AGENDA

Historic District Commission Meeting

HDC Work Permit Staff Review

Property address: 307 N Washington

Figure 1: Building Zones

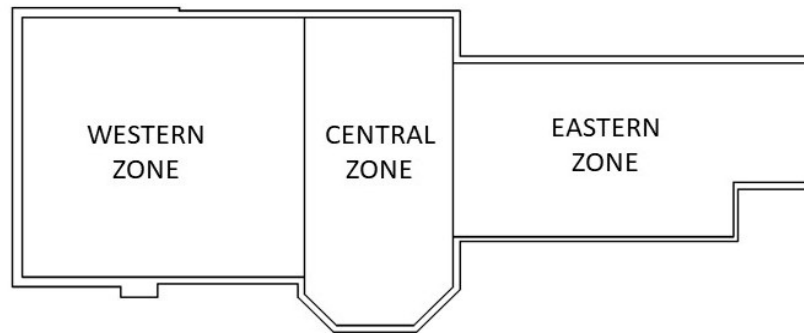
For the purposes of this report and analysis, the tower has been dividing into three zones: Eastern, Central, and Western as shown in Figure 1. The construction methods and materials are relatively uniform within the zones.

Figure 3: Eastern Zone Building Cross Section (Courtesy CDI Architects)

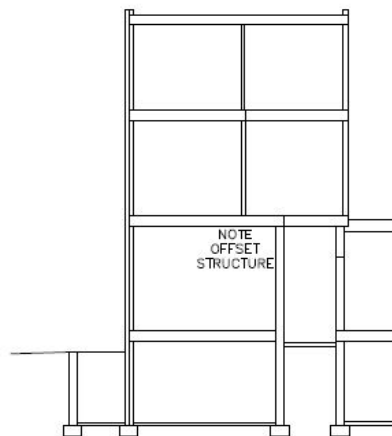
The interior bearing wall on the second and third floors is offset from the foundation by nearly two feet. This creates a situation where the second floor joists are carrying the full loading from the bearing walls above as shown in Figure 3. At the current span, the 2nd floor joists would be overloaded and not meet the minimum deflection requirements.

Since the joists overlap the load bearing wall on the 2nd and 3rd floors, this limits the ability to economically reconfigure the floor plan without reframing the floor/roof.

The 2nd floor framing would at a minimum need to be doubled to account for the offset bearing wall above. However, this is a less than ideal as localized deflection next to the wall would likely occur. The preferred solutions would be to add a bearing wall that aligns with the bearing wall above, or add a beam below to transfer the loading directly to bearing walls or column. Both options would change the available space on the 1st floor and basement and may limit layouts for these areas.

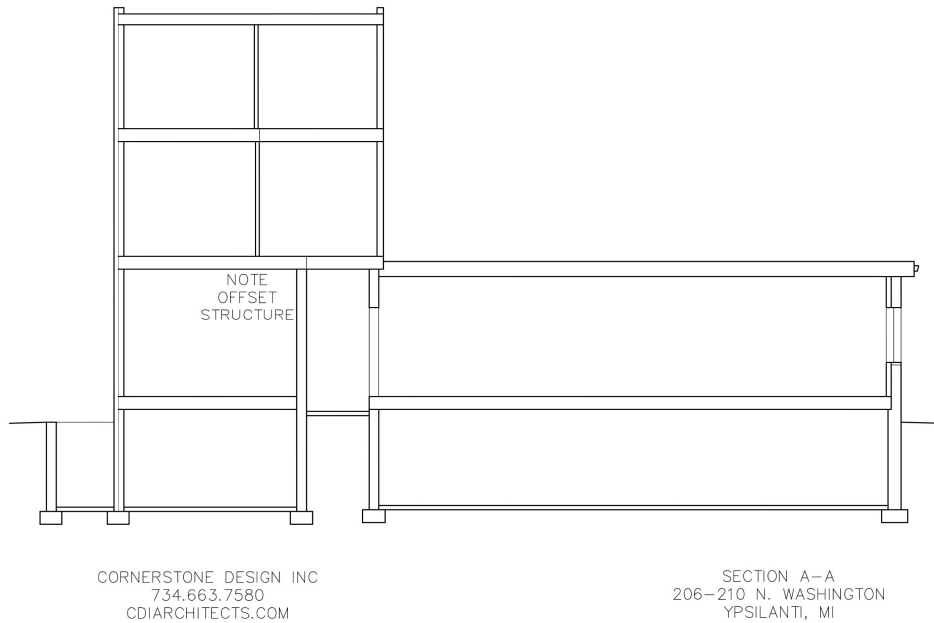
The building was no prize prior to the fire – small apartments, oddly configured, with mostly narrow halls and narrower stairs. Windows are old and in poor condition, and it appears there was minimal insulation. Heat was provided by old radiators from a central boiler, with some apartments having thru-wall air conditioner units (several of the radiators tested positive for lead-based paint). The newer parts of the basement foundation, as well as the many window well walls, appear to be single wythe CMU probably with minimal reinforcing, with some worrisome cracking particularly on the west end of the south basement wall. The one good aspect is the exterior brick, which despite its age, appears mostly in good shape except the area north of the worst part of the fire where mortar is badly worn probably from heat and water penetration.

The fire caused a lot of damage, but the time since the fire has also not been good to the building, with no heat provided (so potential of frost heave damage) and minimal maintenance. The previous owner did apparently put a new roof over part of the tower after the fire, so it was not open to the elements, but there are some signs of water penetration possibly through broken windows and elsewhere, not to mention the water used to fight the fire. Much of the water, of course, eventually flowed to the basement, which would likely be damp anyways without conditioning. As a result, the basement surfaces are pretty well covered with mildew or worse. We should also note that the timelines for these projects are long; to get public approvals, get funding approved, do drawings, get permits, and close on funding could easily result in three or more years of deterioration before construction starts.

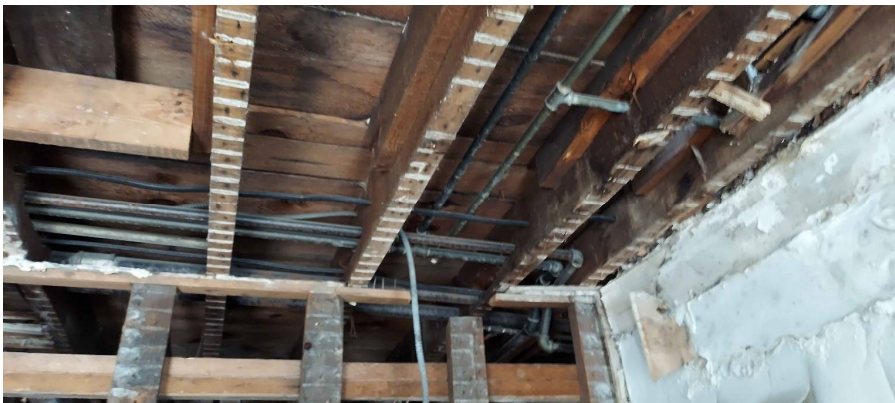
The existing tower framing is also challenging, with 2x8s at 16" on center at the 3rd floor and the roof, and 2x10s at 16" on center at the 2nd floor; we think the first floor was also 2x10s but didn't have good access to measure it due to dangerous conditions. Modern 2x8s could span about 11' with apartment loads (not higher loads in common areas); these are in places spanning as much as 16'. They are older wood, and often closer to the actual 2"x8" size than modern lumber, but it is difficult if not impossible to know what qualities to give it for calculation.

Many of the joists are also frequently cored for pipe penetrations, etc., probably more than should be allowed.
